Subject: **Palo Verde Nuclear Generating Station (PVNGS)**
Units 1, 2, and 3
Docket Nos. STN 50-528, 50-529, and 50-530
Response to Request for Additional Information Regarding License
Amendment Request (LAR) to Revise Technical Specification 3.7.4,
Atmospheric Dump Valves (ADV)s

**RESPONSE TO REQUEST FOR ADDITIONAL INFORMATION
REGARDING LICENSE AMENDMENT REQUEST TO REVISE
TECHNICAL SPECIFICATION 3.7.4,
*ATMOSPHERIC DUMP VALVES (ADV)s***

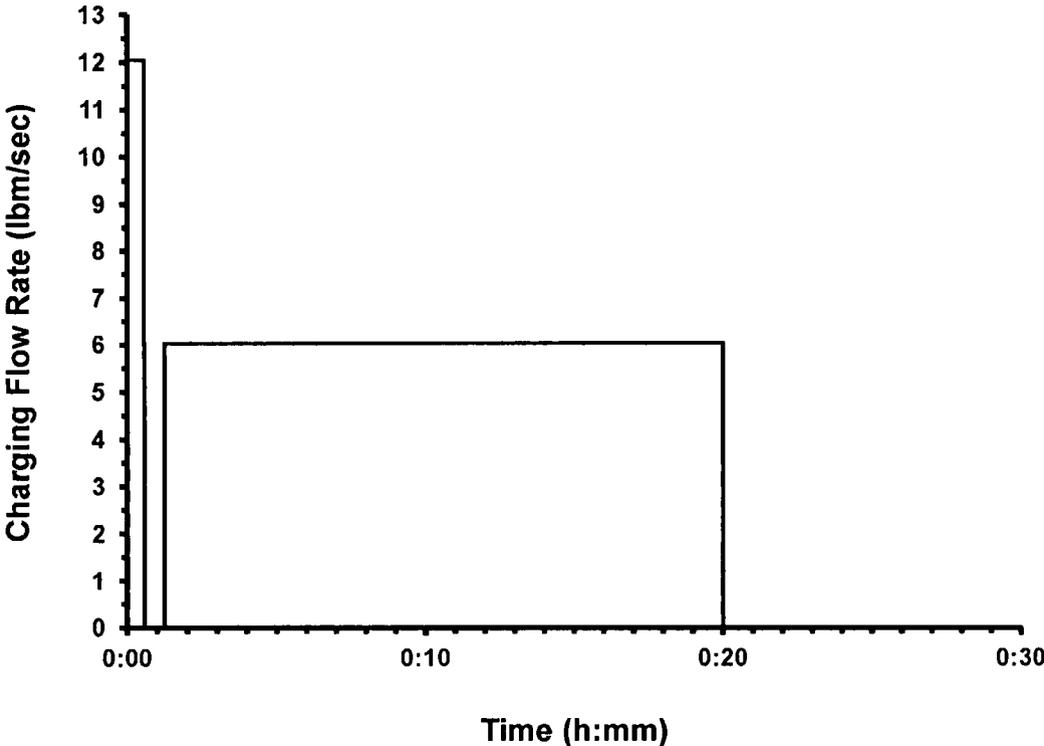
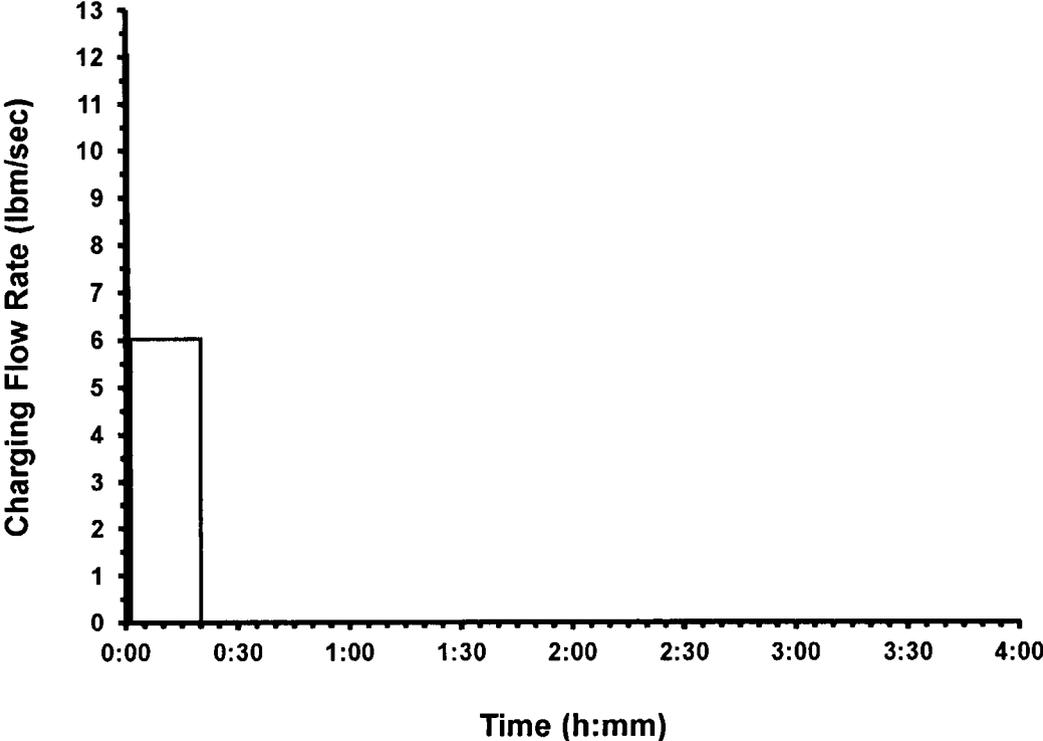
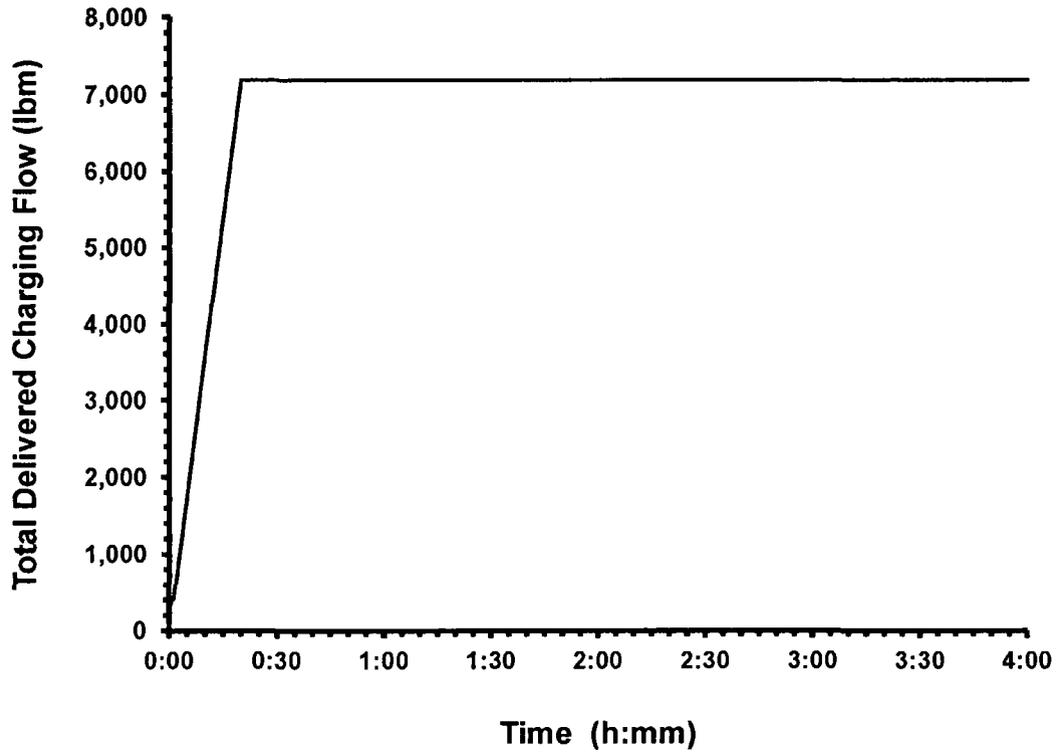
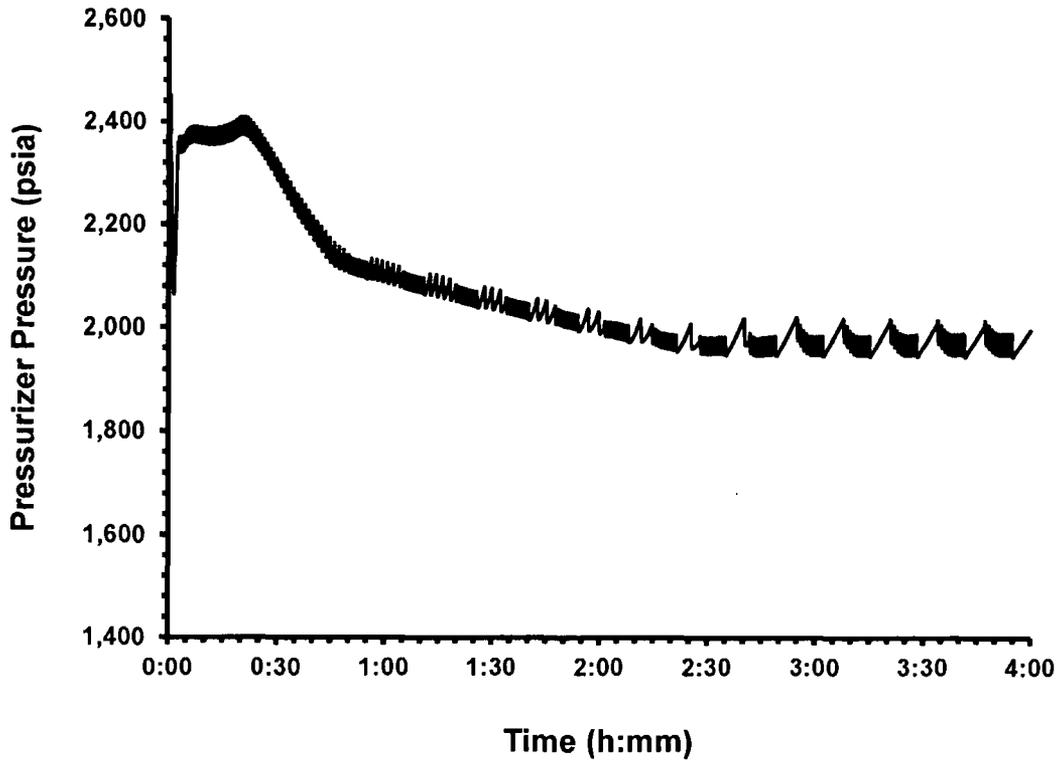
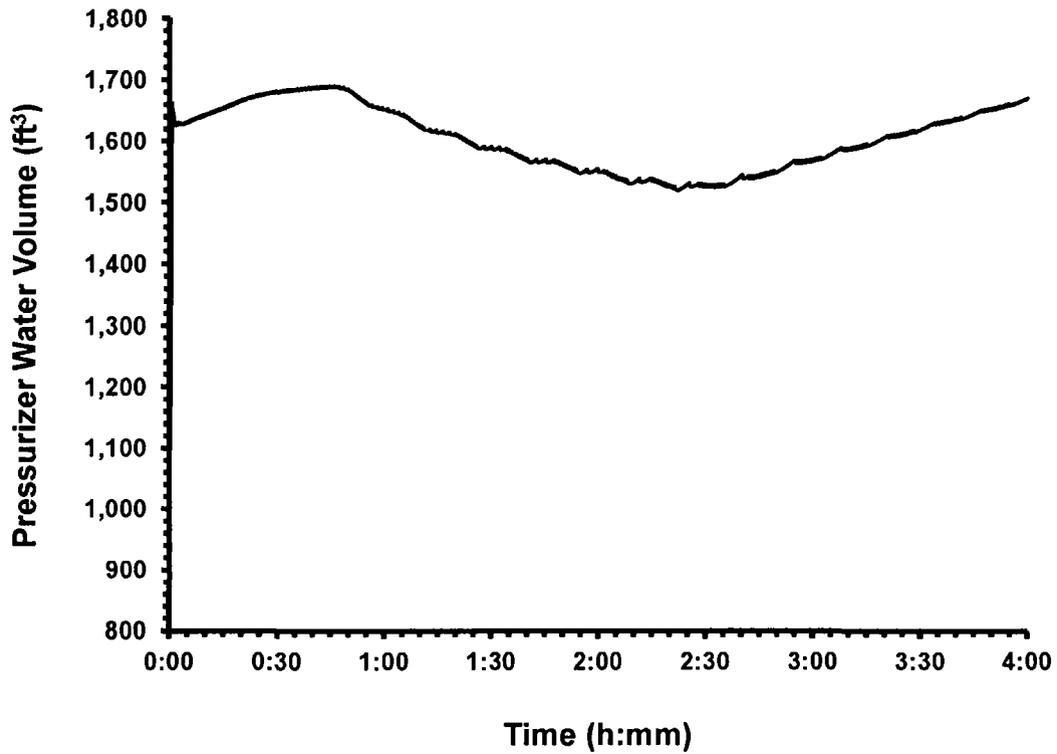
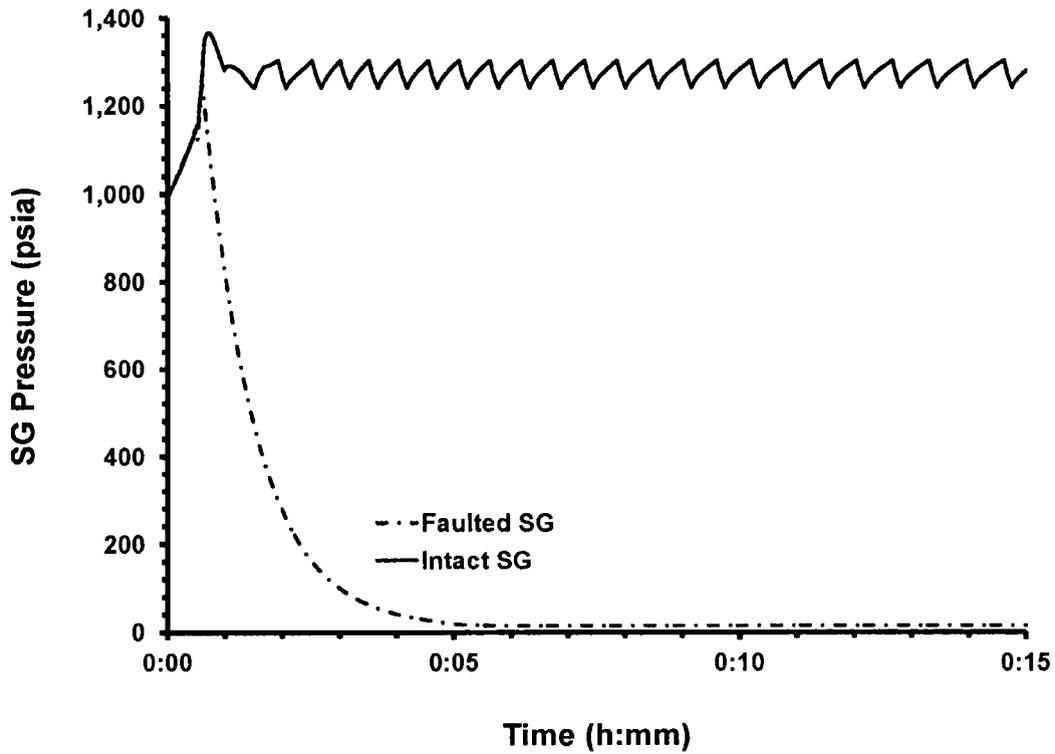
- a. Please provide a table of results that includes key system attributes such as peak RCS pressure, maximum and minimum pressurizer level, and the sequence of events. Also include relevant acceptance criteria.
- b. Please provide plots of the following parameters as functions of time. The NRC staff acknowledges that some plots may need to be truncated if a stable or quasi-stable condition is reached.
 - i. Instantaneous charging flow
 - ii. Total charging flow
 - iii. Pressurizer pressure
 - iv. Pressurizer volume
 - v. Steam generator pressure
 - vi. Steam generator level
- c. Please discuss how, in the context of an FWLB event and associated control room procedures, operators will ensure that the charging pumps are secured

- Figure 3-1 FWLB Demonstration Analysis – Short-Term Instantaneous Charging Flow Rate vs. Time

- Figure 3-2 FWLB Demonstration Analysis – Long-Term Instantaneous Charging Flow Rate vs. Time
- Figure 3-3 FWLB Demonstration Analysis – Total Delivered Charging Flow vs. Time
- Figure 3-4 FWLB Demonstration Analysis – Pressurizer Pressure vs. Time
- Figure 3-5 FWLB Demonstration Analysis – Pressurizer Water Volume vs. Time
- Figure 3-6 FWLB Demonstration Analysis – Short-Term Steam Generator Pressure vs. Time
- Figure 3-7 FWLB Demonstration Analysis – Long-Term Steam Generator Pressure vs. Time
- Figure 3-8 FWLB Demonstration Analysis – Short-Term Wide Range Steam Generator Level vs. Time
- Figure 3-9 FWLB Demonstration Analysis – Long-Term Wide Range Steam Generator Level vs. Time
- Figure 3-10 FWLB Demonstration Analysis – Short-Term Steam Generator Water Mass vs. Time
- Figure 3-11 FWLB Demonstration Analysis – Long-Term Steam Generator Water Mass vs. Time
